Baxter Brenton (BD) Ltd

SFB #7, 1st Floor, DEPZ(Old Zone), Ganakbari, Ashulia, Savar, Dhaka - 1349
(23.94997N 90.27216E)

10th May 2014

ACCORD
on Fire and Building Safety in Bangladesh

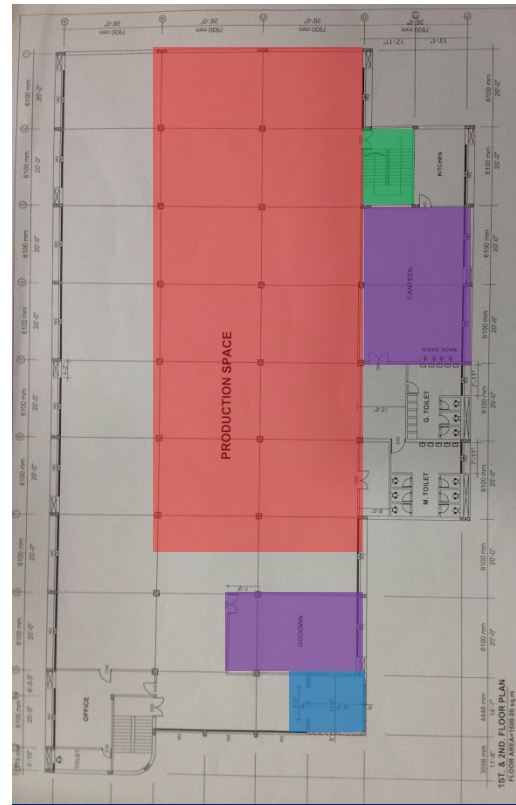
Heavy loading in both buildings, particularly Building 2, and lack of a Loading Plan

- Areas of very high loading were observed in the fabric storage area at 1st Floor level of Building 2.
- This of particular concern as extensive cracking to the top of the 1st Floor slab at the location of the beams was evident throughout the floor.
- Further areas of high loading were noted at the water tanks and storage rooms at roof level of both buildings, and the storage areas at 2nd Floor level of Building 1.
- Building Engineer to check that the different slab constructions have been adequately designed to accommodate these loadings.
- A Loading Plan for all floor plates is to be produced, implemented on the floor and actively managed.

First Floor Plan – Building 1

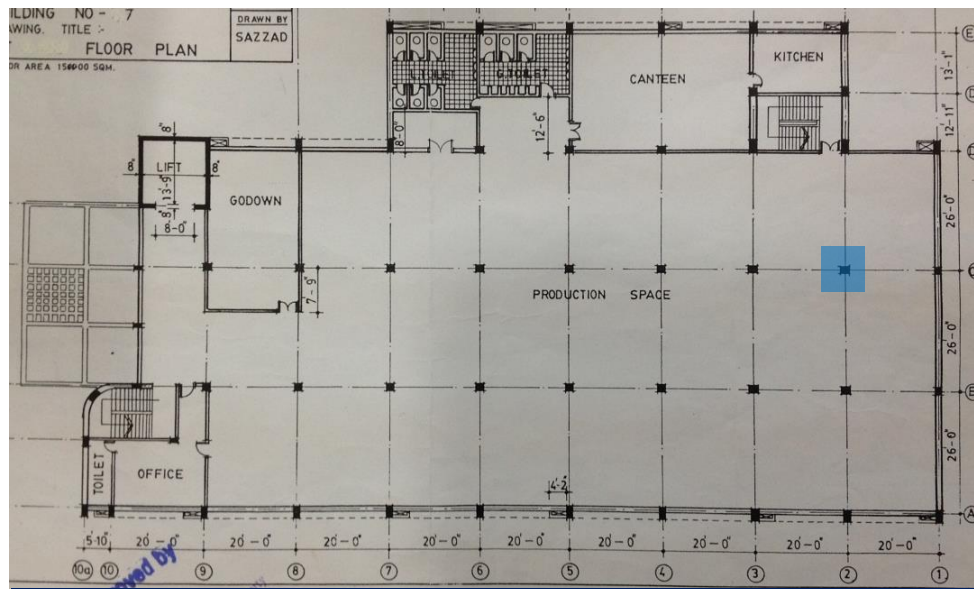
- Cursory calculations indicate that the working stresses of the columns at Ground Floor level are above normal design limits.
- Building Engineer to verify concrete stresses and in-situ concrete strength.

- Testing of the Ground Floor columns was not possible in either building on the day of the survey, owing to the fact that these floors are currently occupied by other companies.
- Stone aggregate was observed in the 1st Floor columns of Building 1.
- The reinforcement quantities observed at 1st Floor level coincides with the values shown in the column schedule.
- High yield steel reinforcement is called up in the drawings for both buildings, and was observed at Roof level.

Extent of
Walkways

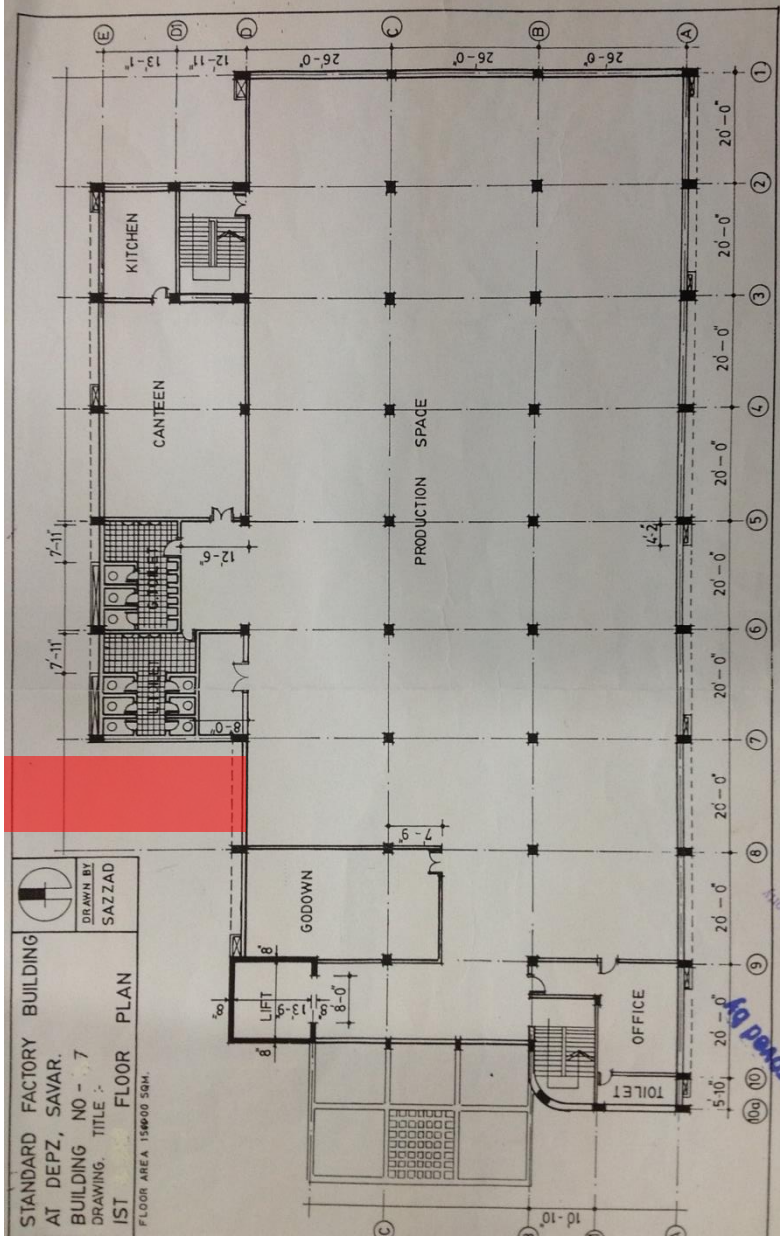
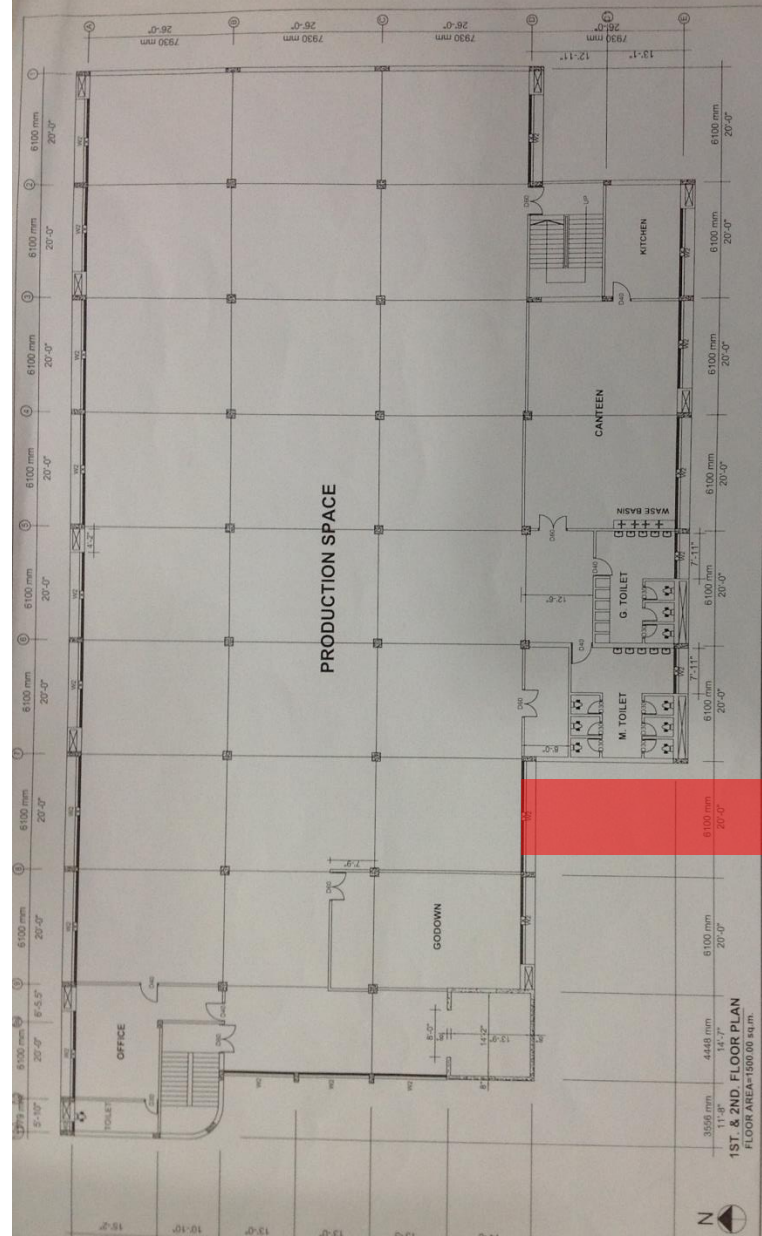
- Buildings 1 and 2 are connected to adjacent buildings by a ramp and bridge link structure, which provides elevated pedestrian and delivery access to the buildings at 1st and 2nd floor levels.

- The design of these structures, particularly the connection detail with the buildings, is not clear.
- Exposed slab and wall reinforcement in the structures was observed to run through, thereby providing connection with the building.

- Relative movement between the buildings and the structures does not appear to have been allowed for, and extensive cracking was observed.
- There were no drawings showing the structures.

- The link bridge appeared to be used as a storage area at 1st Floor level.
- Building Engineer to review the design of the ramp and bridge link structure, with special emphasis on the connection detail with the buildings, and to demonstrate that if any load is imparted to the building this has been adequately designed for.

- A full set of as-built drawings is to be provided detailing the buildings and the connecting structures.

Extent of lightweight structures

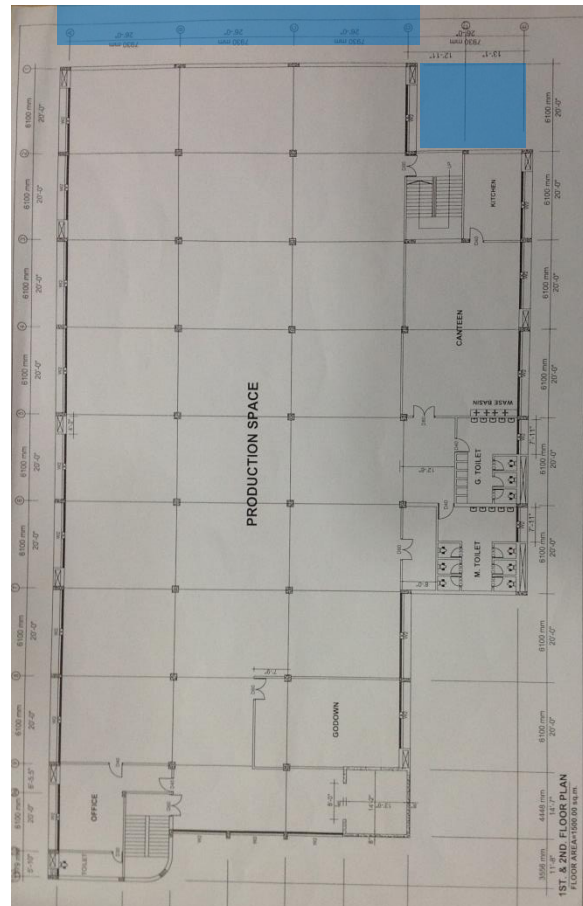
- Included in the factories are a number of lightweight structures located on the Roof of Building 1 and at Ground Floor level around Building 2.
- These structures appear to be non-engineered.
- Building Engineer to review the design of these lightweight structures to guard against uplift and lateral instability, with particular emphasis on connections and bracing, and to implement any remedial / upgrade works as required.

Building 1 - Cracking to beam soffit

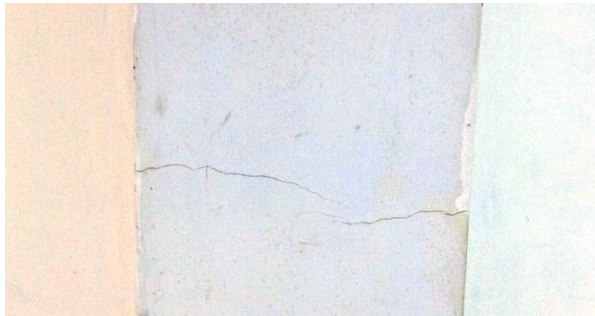
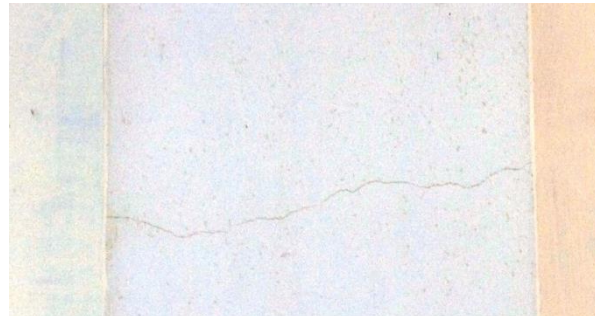
- Cracking was observed in a number of locations throughout the buildings.
- Extensive cracking was observed on the 1st Floor slab of Building 2 at the location of the support beams, and to areas of the façade where the walkways meet both the buildings as highlighted in Observations section above.
- Hairline cracking was observed to a number of beam soffits in both buildings at all floor levels. Cracking to areas of the façade and the stair-core walls of Building 2 was also observed.
- A number of cracks have been filled and / or painted over, particularly at Ground Floor level.
- Building Engineer to investigate the cause of the cracking and to carry out remedial works to the structure as required.
